EAST TOWN CROSSING

The submitted civil plans contain review comments ("markups") that must be addressed prior to landuse approval as well as informational comments that can be addressed at time of civil application. Please refer to the DRT Letter "Action Items" for markups that must be addressed for landuse approval. [Prelim. Civil Dwg Part 2, Pg 1 of 15]

EAST TOWN CROSSING SEC. 26,35/ TWP. 20 N./ RGE. 4 E., W.M. PIONEER WAY E. FRONTAGE STORM PLAN

SEC. 26,35/ TWP. 20 N./ RGE. 4 E., W.M. PIONEER WAY E. FRONTAGE STORM NOTES & DETAILS

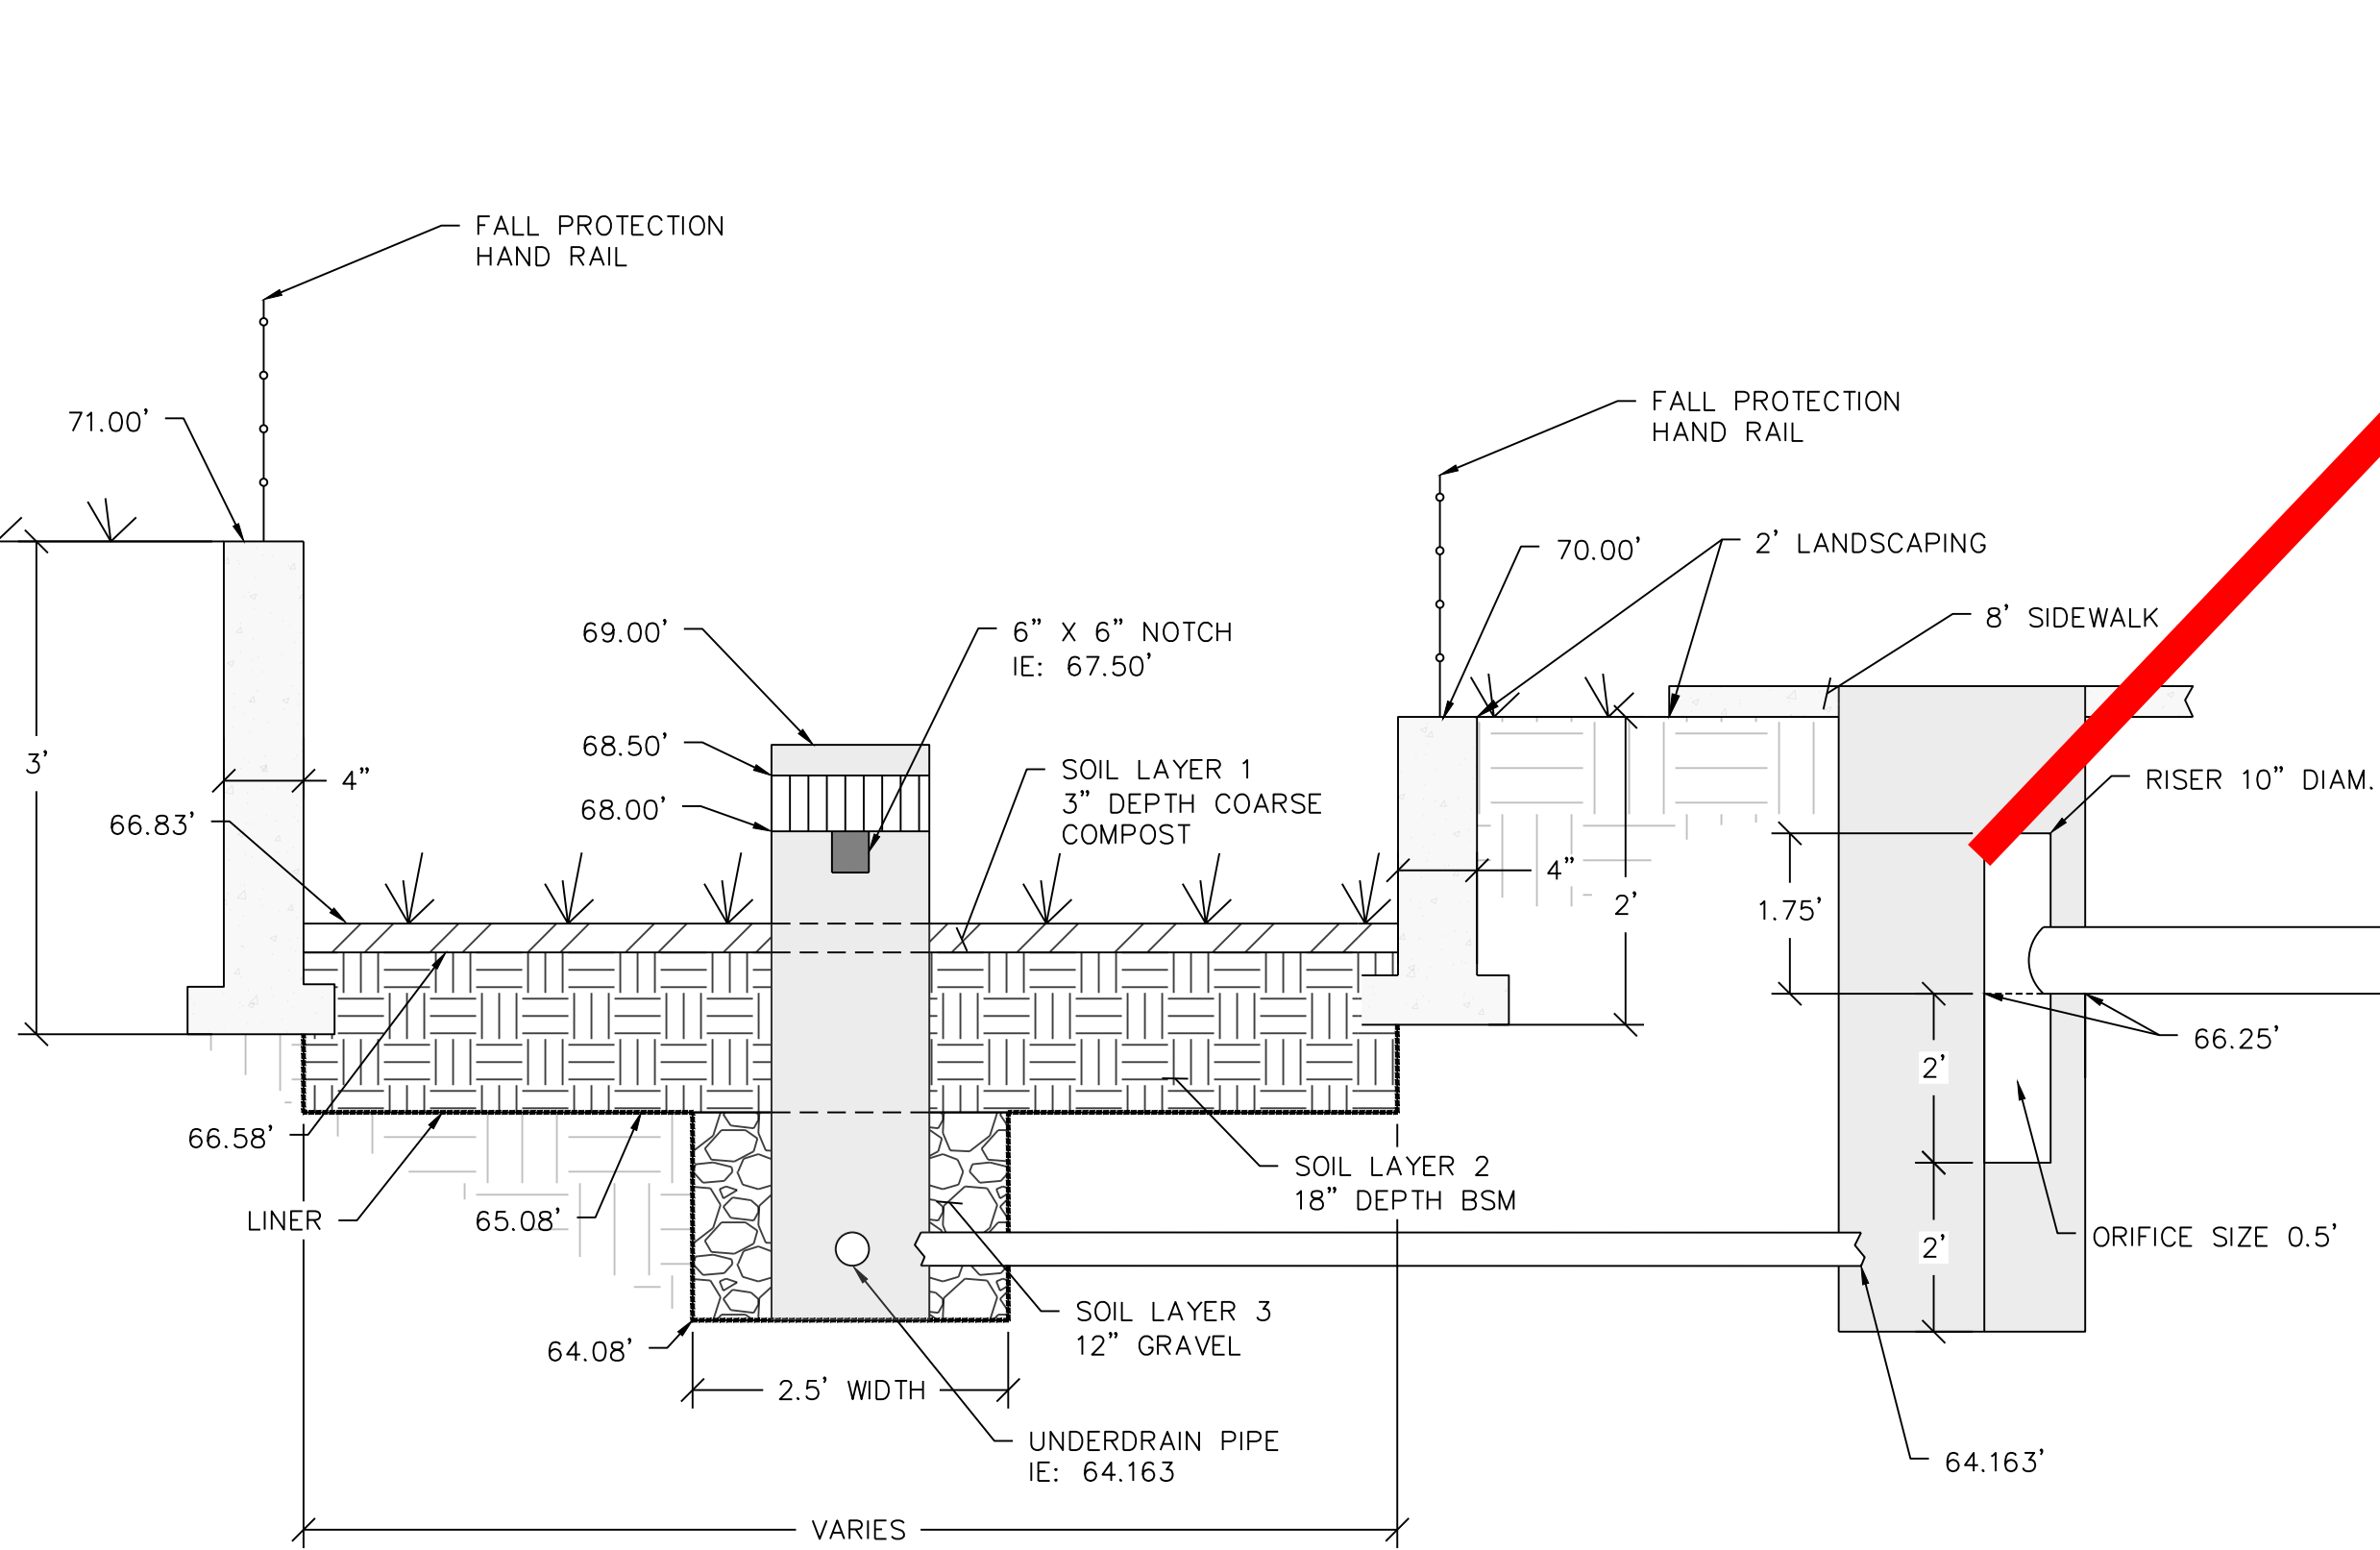
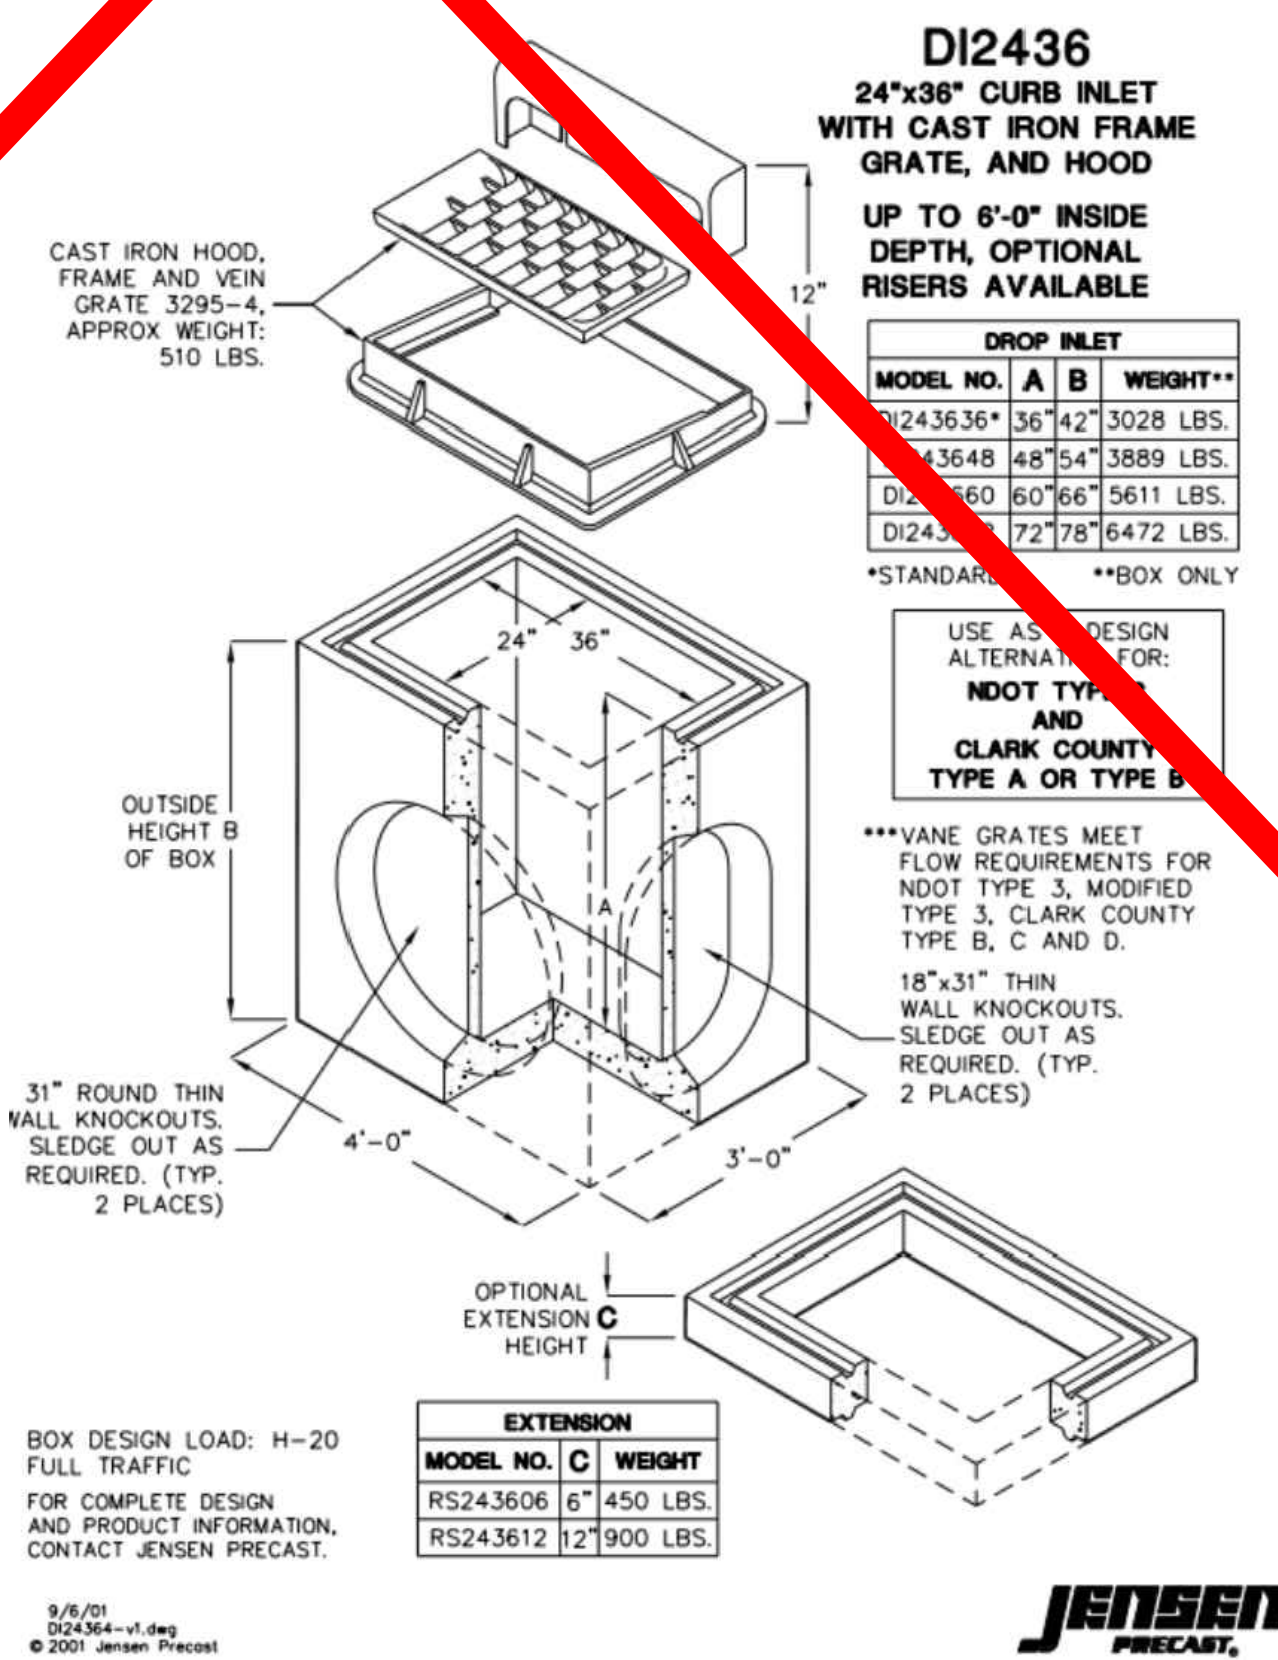
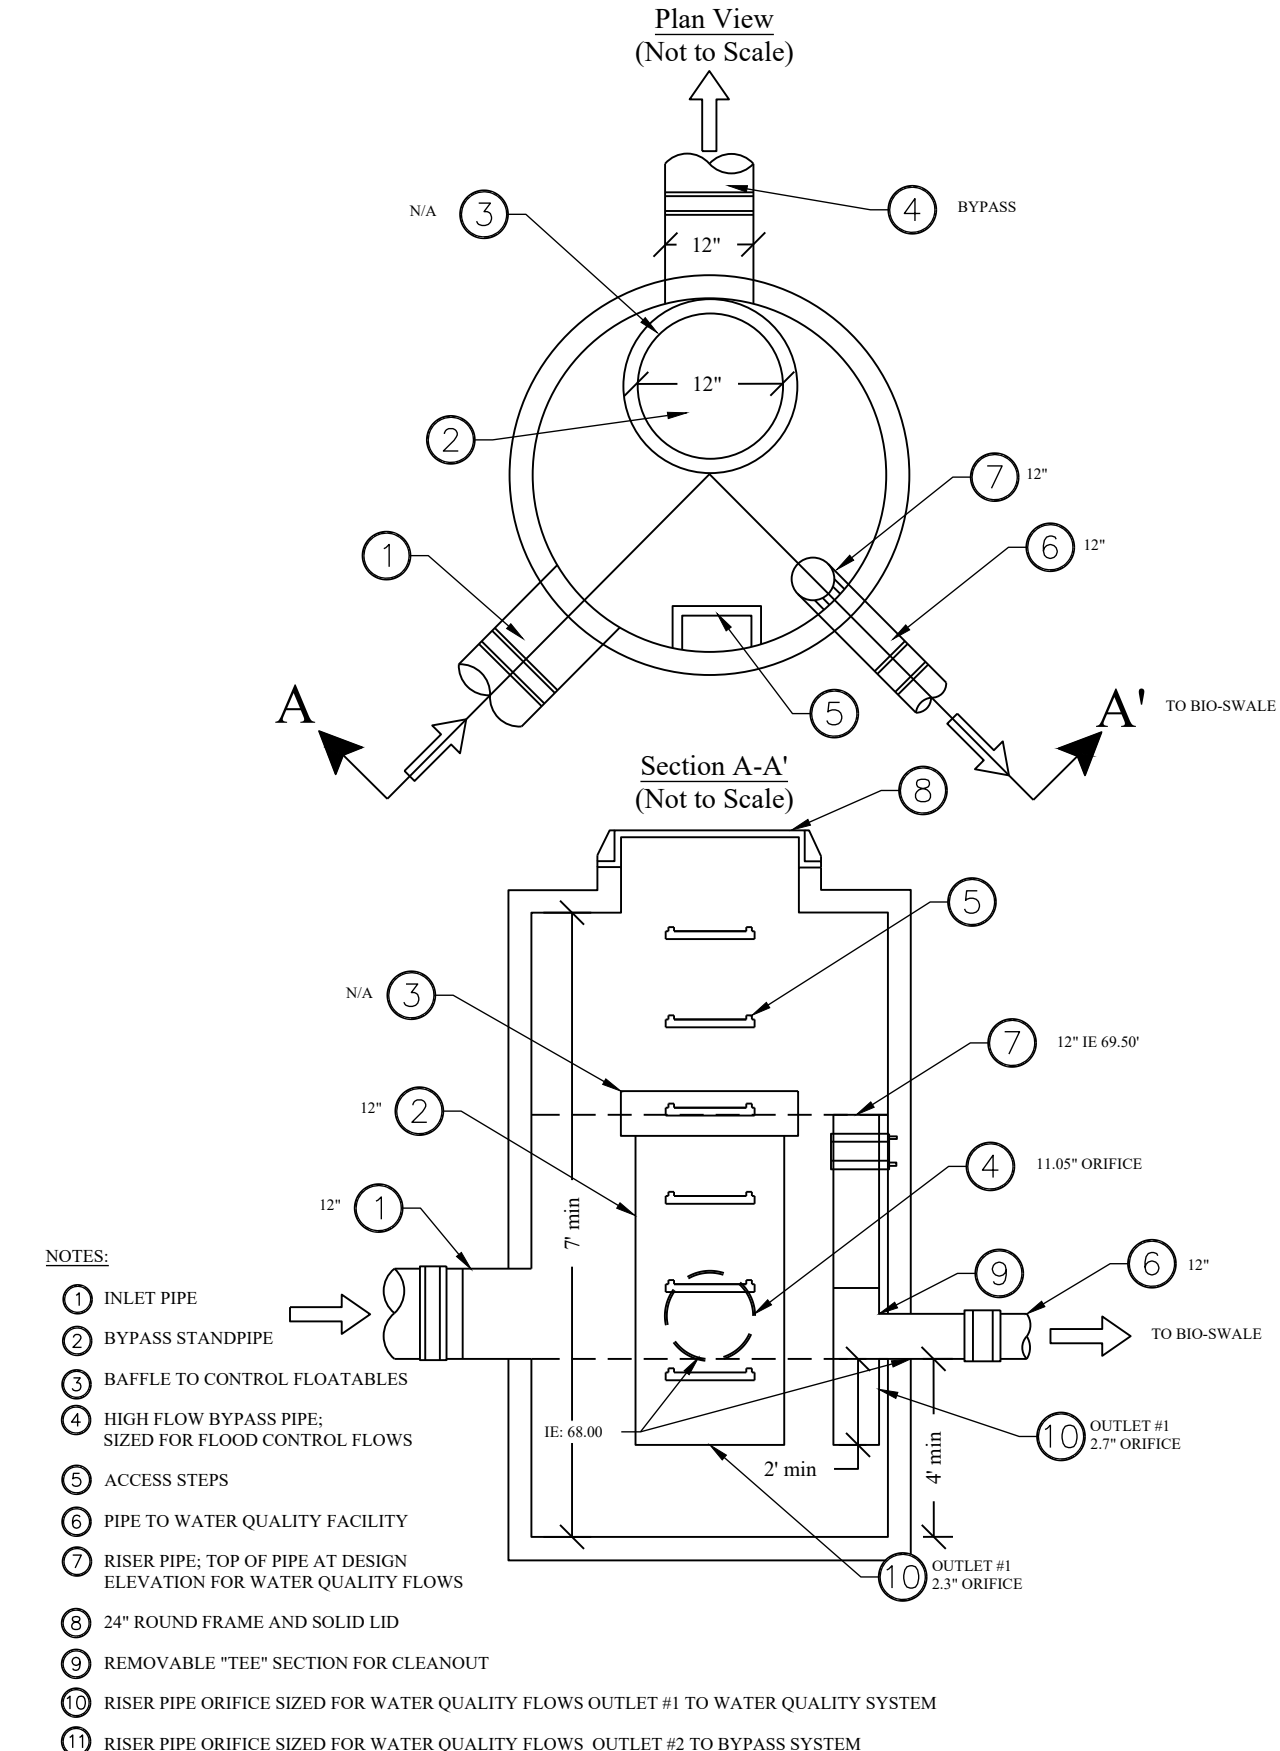
Confirm-Based on the revised Preliminary Storm Design submitted by McInnis Engineering, it does not appear that this sheet is relevant.
 [Prelim. Civil Dwg Part 2; Pioneer Frontage Storm Notes and Details; Pg 6 of 15]
